CHANGE TYPE: Modification

CHANGE SUMMARY: Guidance has been provided to ensure continuity of fire-resistive protection where secondary steel attaches to either primary or secondary fire-resistance-rated structural members.

704.6.1 Secondary Attachments and Fireproofing

Protection of secondary attachments.

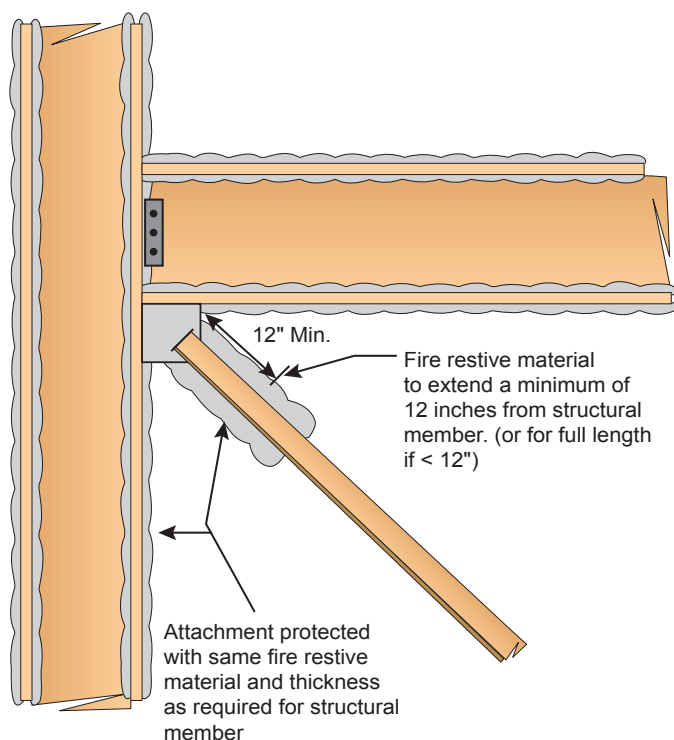
2021 CODE TEXT: **704.6.1 Secondary attachments to structural members.** Where primary and secondary structural steel members require fire protection, secondary steel attachments to those structural members shall be protected with the same fire resistive material and thickness as required for the structural member. The protection shall extend away from the structural member a distance of not less than 12 inches (305 mm), or shall be applied to the entire length where the attachment is less than 12 inches (305 mm) long. Where an attachment is hollow and the ends are open, the fire-resistive material and thickness shall be applied to both the exterior and interior of the hollow steel attachment.

One added aspect of this new provision addresses the protection of attached hollow members with open ends. Because heat can impact both the interior and exterior of a hollow member, the fire-resistive protection must be installed on both the interior and exterior of the attached element for the required 12-inch distance.
